Comments on #SDP-26-0005 - Planning & Zoning: Site Development Plan

Application Number: #SDP-26-0005
Application Type: Site Development Plan
Date: October 15, 2026
Address: 4502 VINEYARD PINE LN, ROLESVILLE, NC 27571
Parcel: 1758453022

Site Development Plan
SDP-26-0005 (SDP-23-06)
Rolesville, Wake County, North Carolina
Oatland Commercial
4502 Vineyard Pine Lane (PIN:1758453022)

Cover Sheet
Oatland Commercial (SDP-26-0005)
4502 Vineyard Pine Lane
Rolesville, Wake County, North Carolina

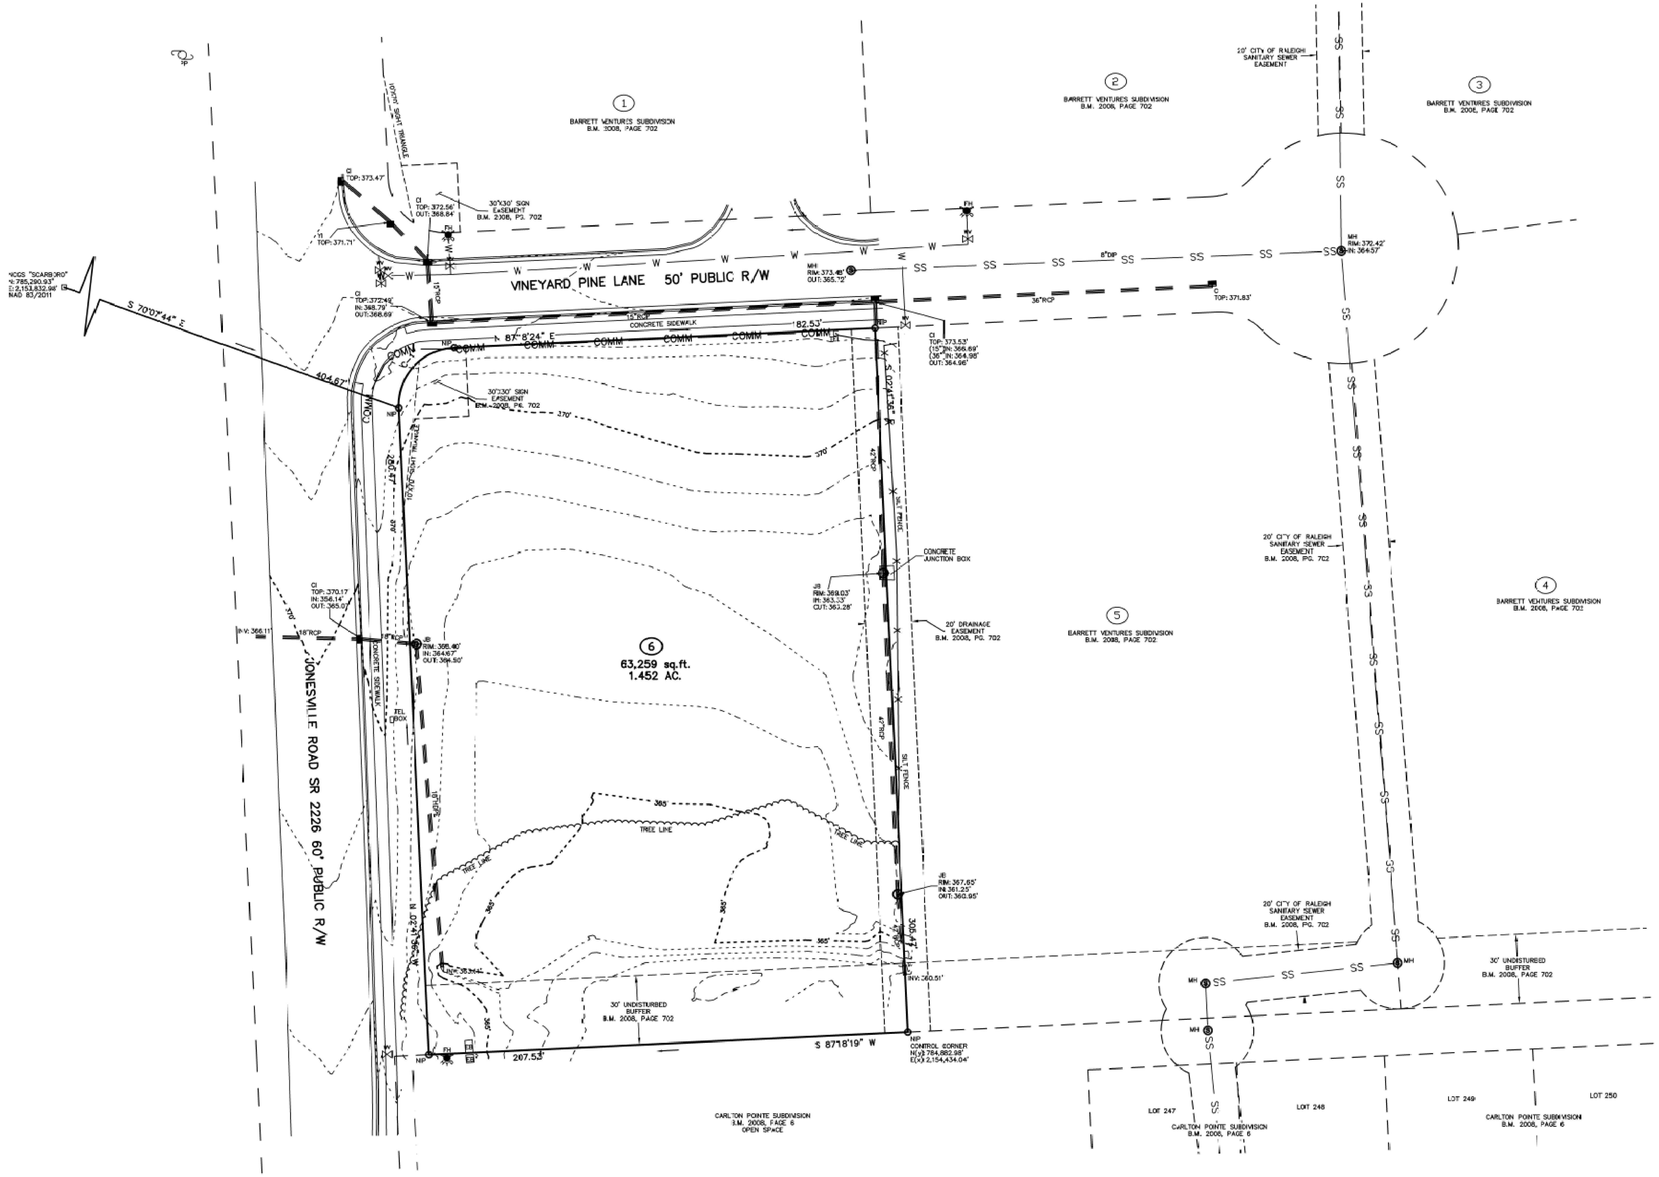
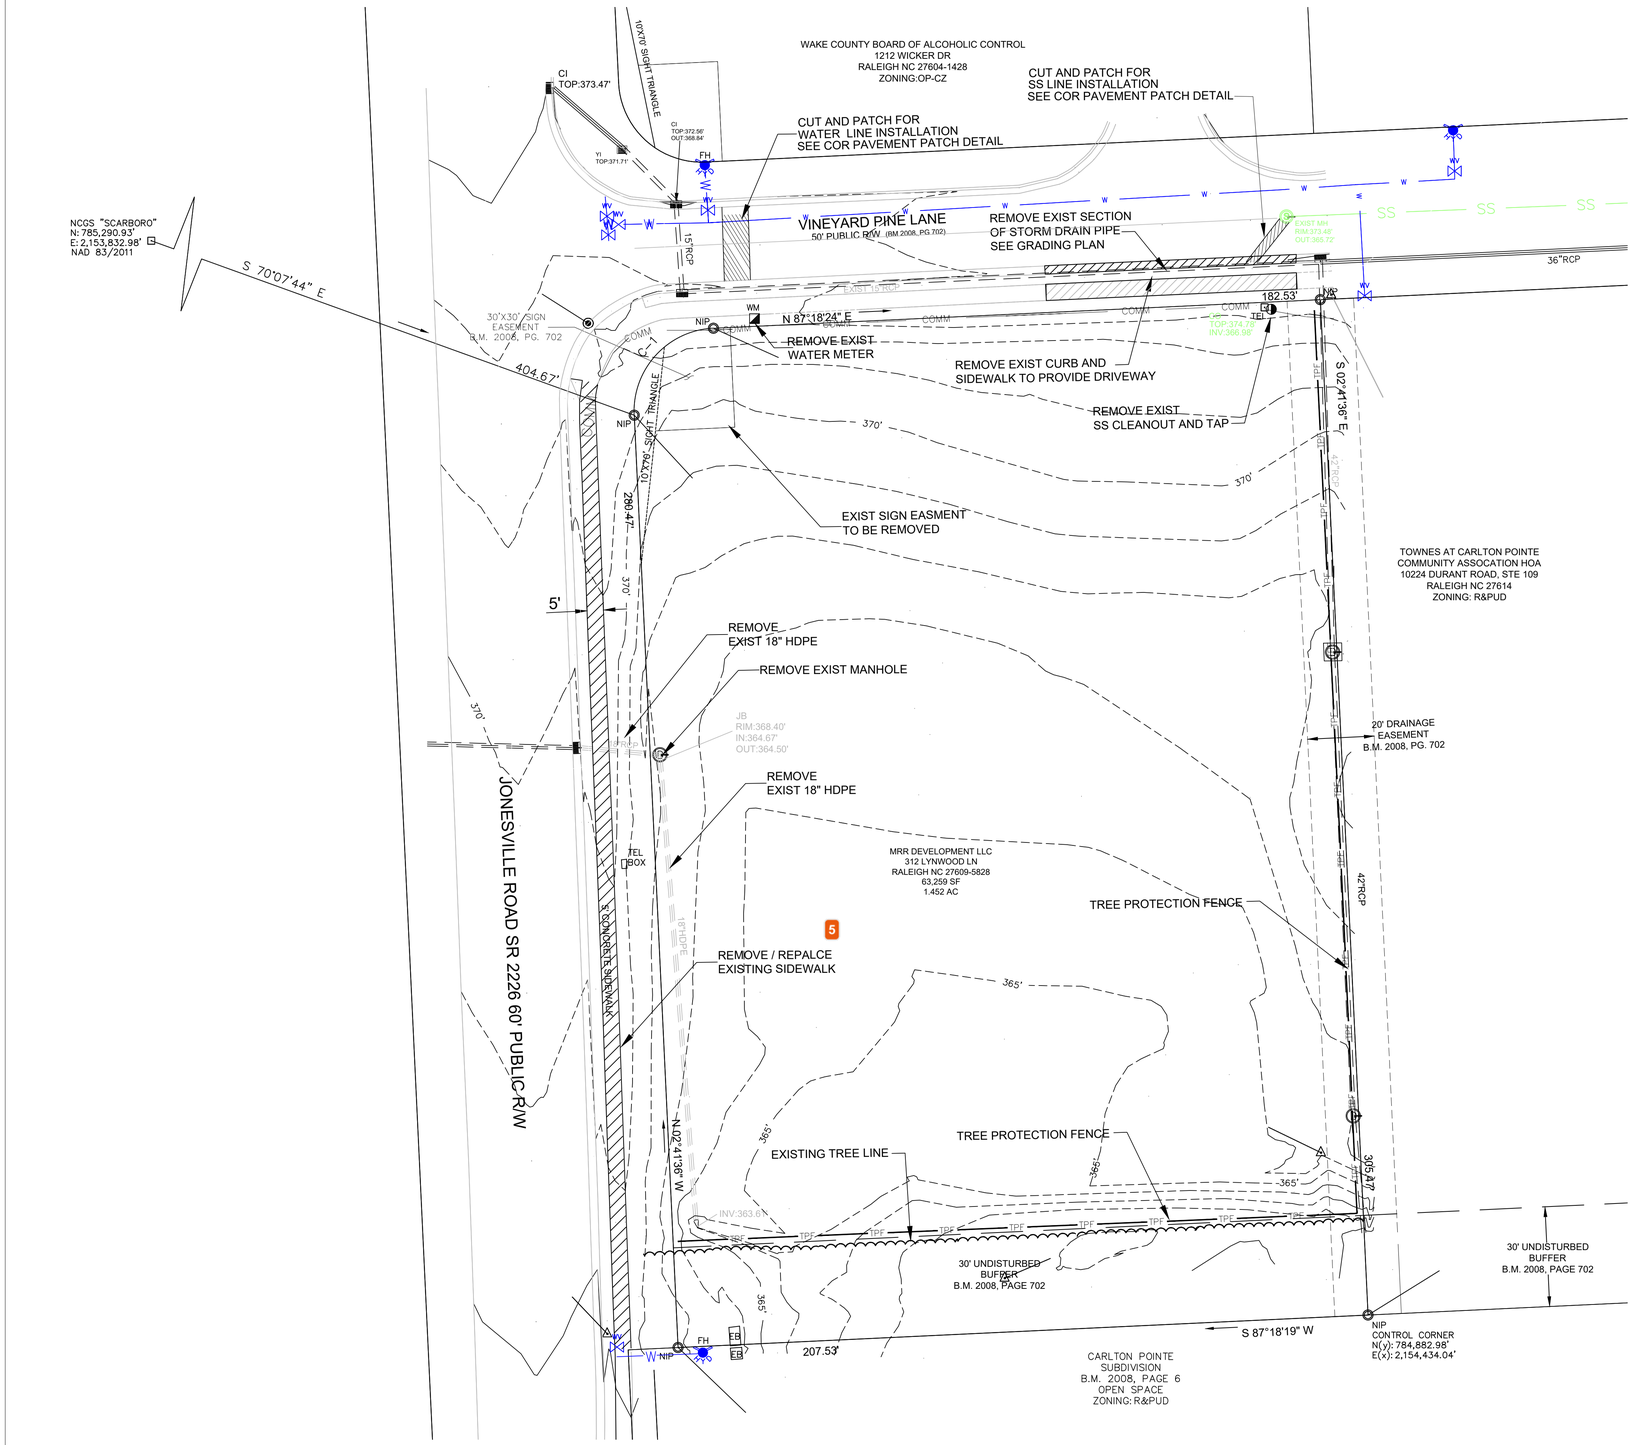
This "BOM/PAGE" reference is the Deed recordation info, not the Book of Maps which is BM2008/Pg702 - revise accordingly. It's fine if you want to ADD A ROW for "Deed" - and that Bk/pg reference.

3 Michael Elabarger
This "BOM/PAGE" reference is the Deed recordation info, not the Book of Maps which is BM2008/Pg702 - revise accordingly. It's fine if you want to ADD A ROW for "Deed" - and that Bk/pg reference.

Exist. Conditions & Demo Plan

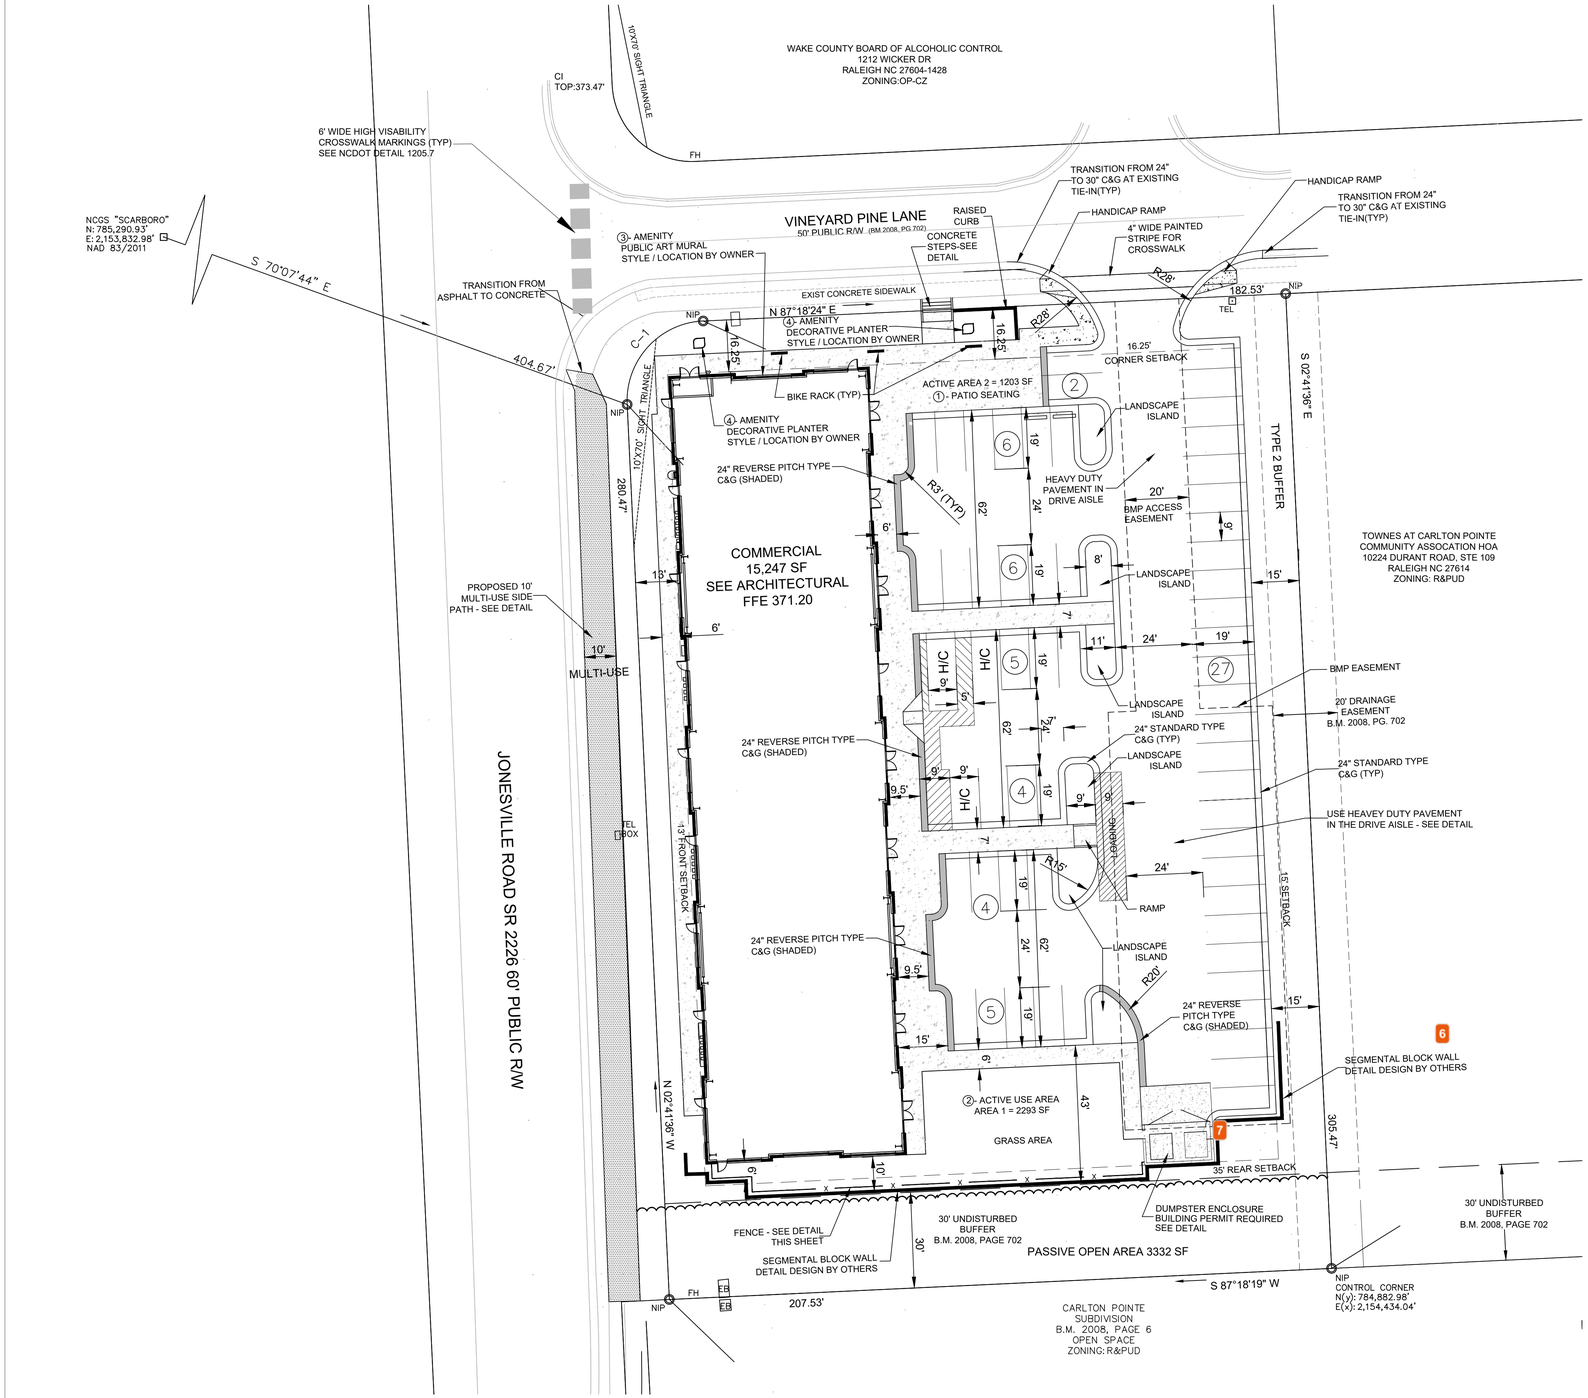
Small typo- please change to "replace" instead of repalce

5 **Michele Raby**
Small typo- please change to "replace" instead of repalce

Site Plan
Oatland Commercial (SDP-26-0005)
4502 Vineyard Pine Lane
Rolesville, Wake County, North Carolina

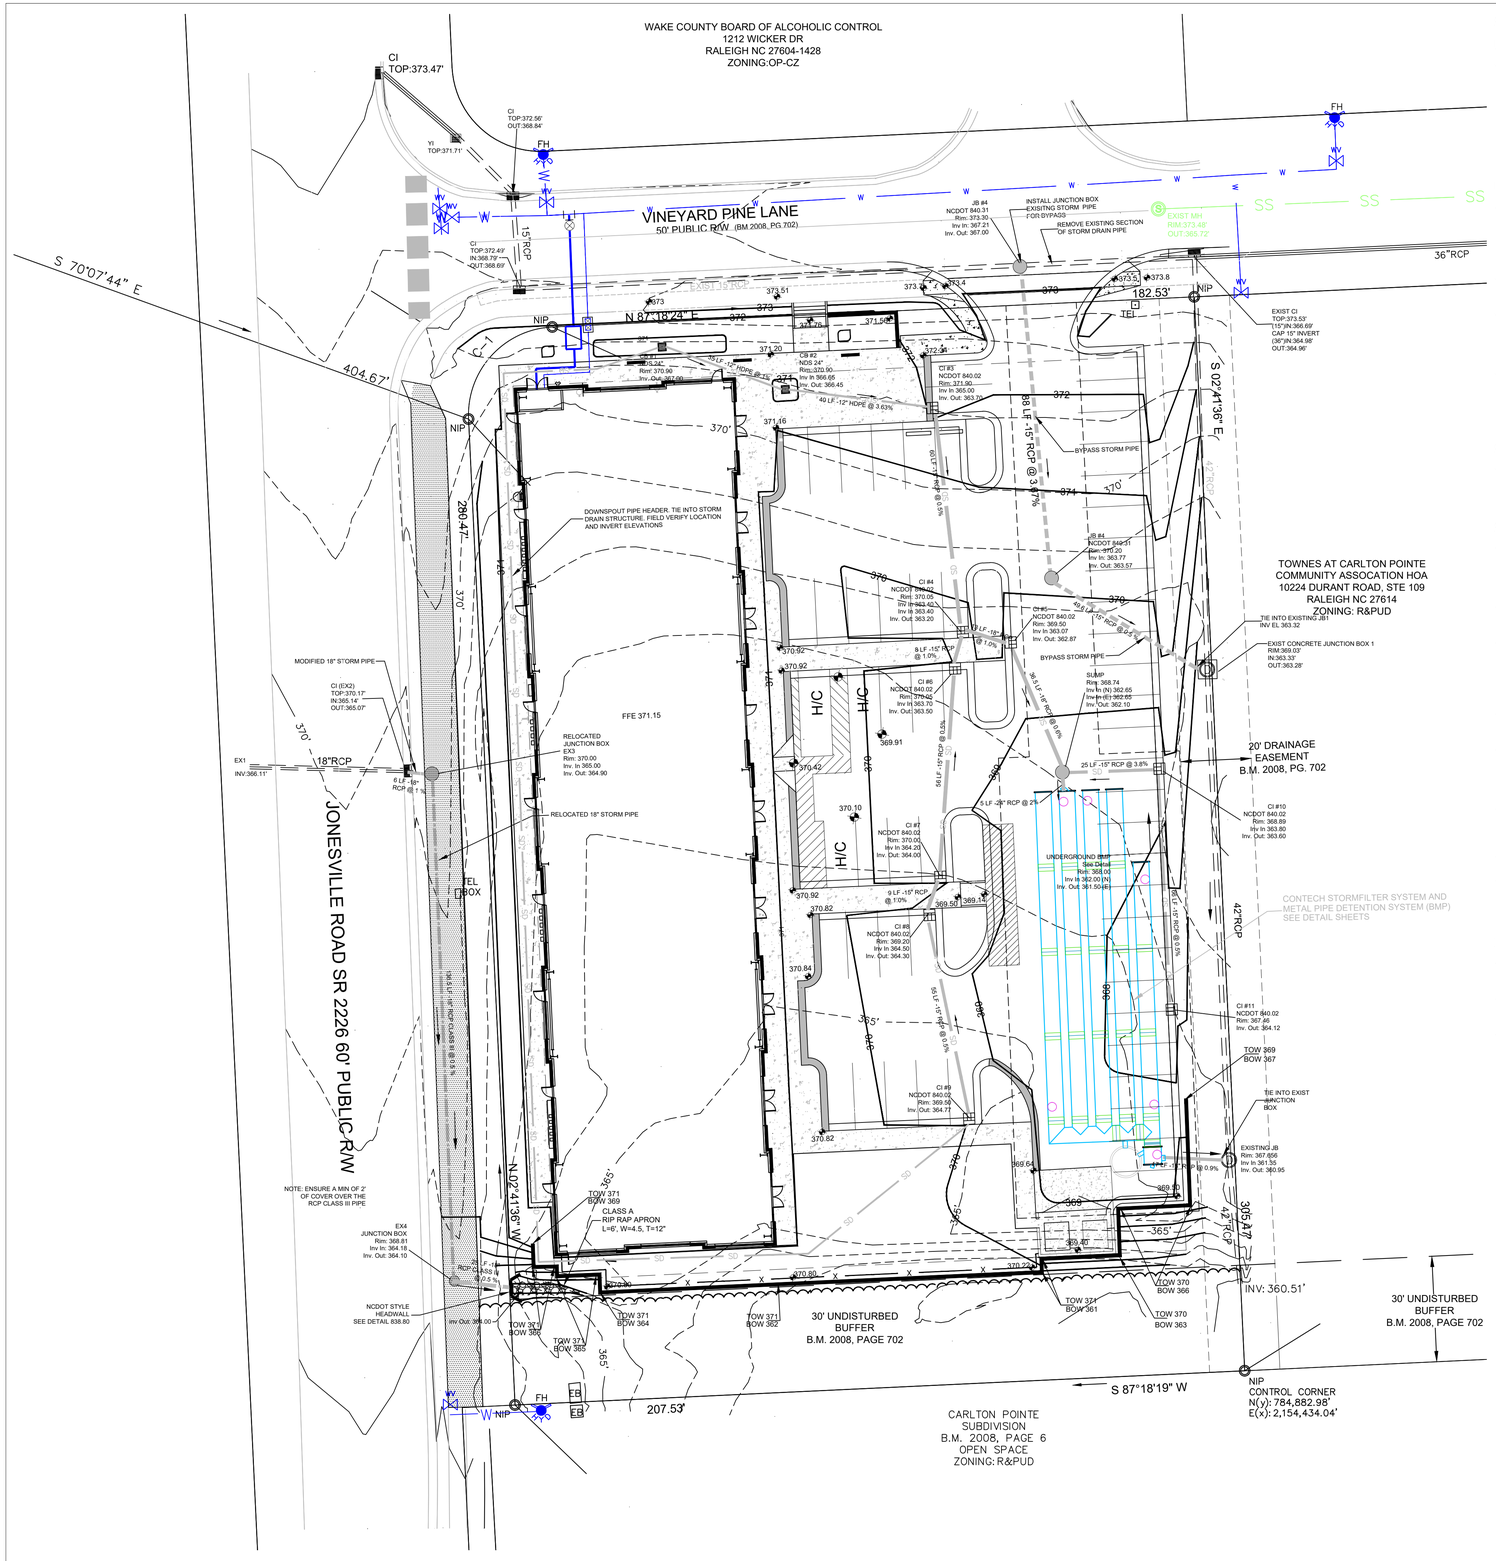
Comment: A retaining wall will require a separate permit.

Comment: Dumpster will require a separate WC permit.

6 Michele Raby
Comment: A retaining wall will require a separate permit.

7 Michele Raby
Comment: Dumpster will require a separate WC permit.
